HISTORIC AND DESIGN REVIEW COMMISSION

Agenda Item No: 17

HDRC CASE NO: 2016-401
COMMON NAME: 523 N Colorado
ADDRESS: 525 N COLORADO ST
LEGAL DESCRIPTION: NCB 2230 BLK 3 LOT N 54.3 FT OF 1
ZONING: I-1 HL
CITY COUNCIL DIST.: 5
LANDMARK: Yes
APPLICANT: Johnny Estrada
OWNER: Paul Gomez
TYPE OF WORK: Install doors and windows, roof repair
REQUEST:

PROPOSED EXTERIOR REPAIRS 523 N COLORADO AND MATERIALS

Front Elevation

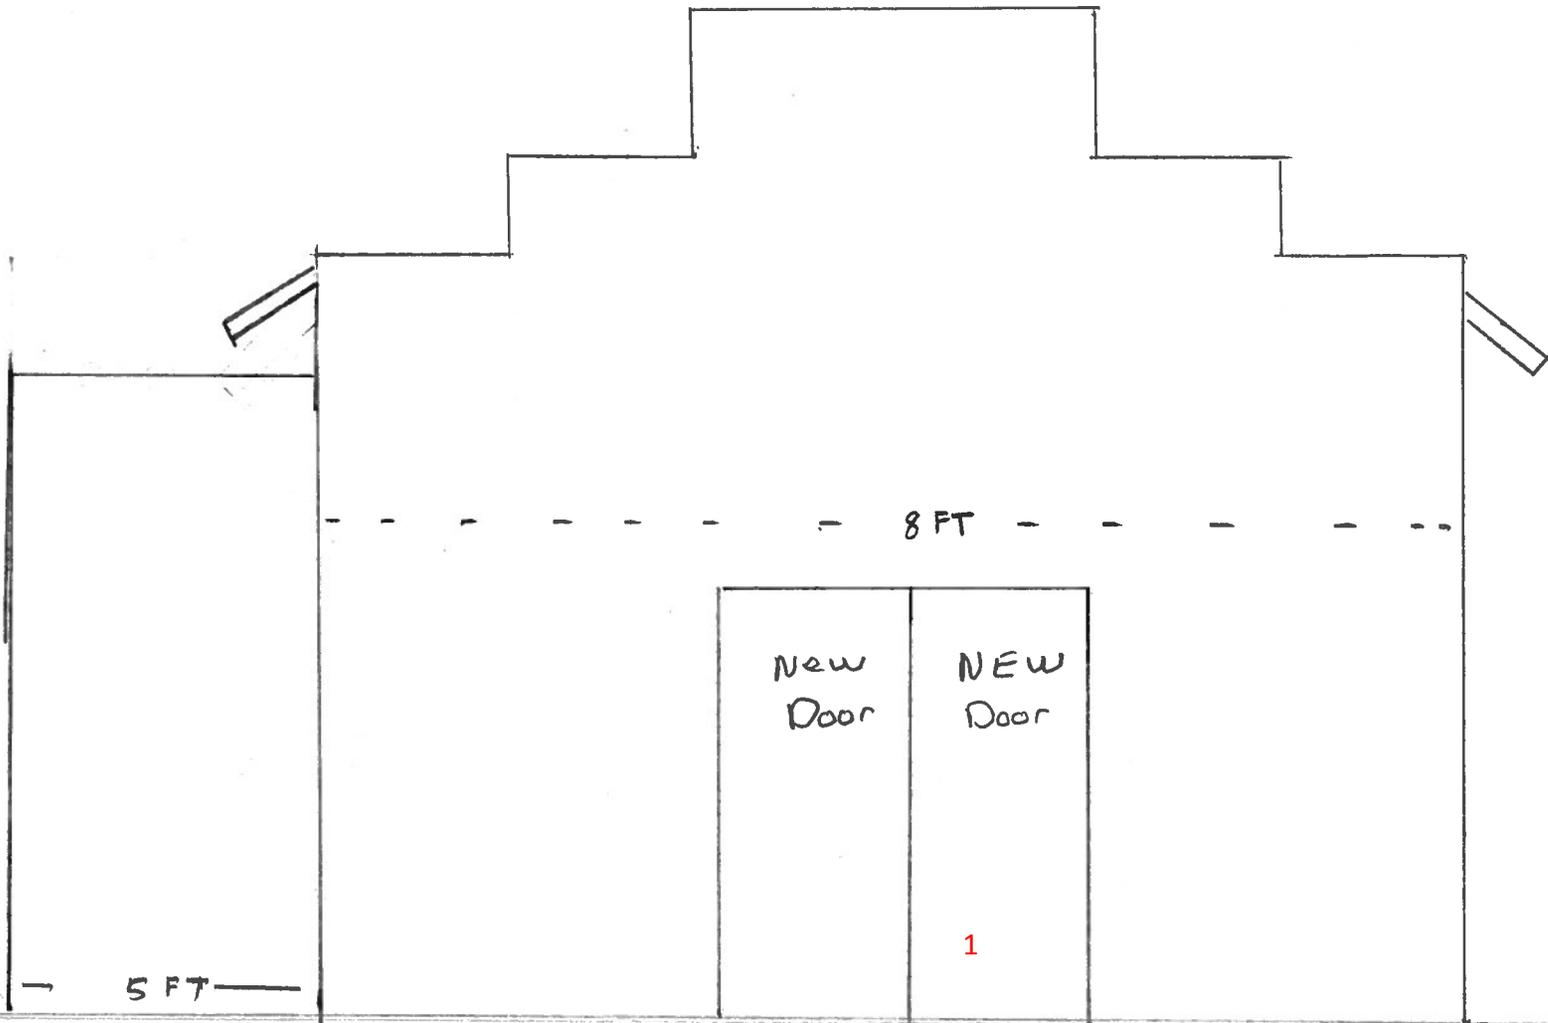
- b. The applicant received administrative approval to repair siding, paint, repair the existing roof, and repair the foundation.
- c. There are no existing doors and the openings are boarded up. The applicant is proposing to install two half-light doors on the front wood door screens, a solid wood paneled door on the right, and double solid wood doors on the rear addition. According to the Guidelines for Exterior Maintenance and Alterations 6.A. and B., openings should be preserved and new doors should match the size, material and profile of the historic element. Staff finds the proposed front half-light doors are not appropriate for the architectural style of the building, thus not consistent with the Guidelines. Staff recommends that the doors have a full light in each.

- 2 Elevation of front view of property. Not to scale.
- 3 Picture of front view. All damaged siding will be replaced with #117 yellow pine siding which is original to building. The trim boards shall be yellow pine original to building. The front entrance doors will be wood doors with ½ screens. If the front doors are not used for entrance and rear doors are used for entrance, then front doors will be wooden with 9 lite windows. Screen doors will be added as original to building. The front part of building shall be painted white with green trim as original to building. The doors shall be treated with transparent stain original to building.

1. That the front doors have full window lights.
2. That the replacement glass be clear.
3. That the applicant test the roof sealant product on a rear test area and submit to staff to review.
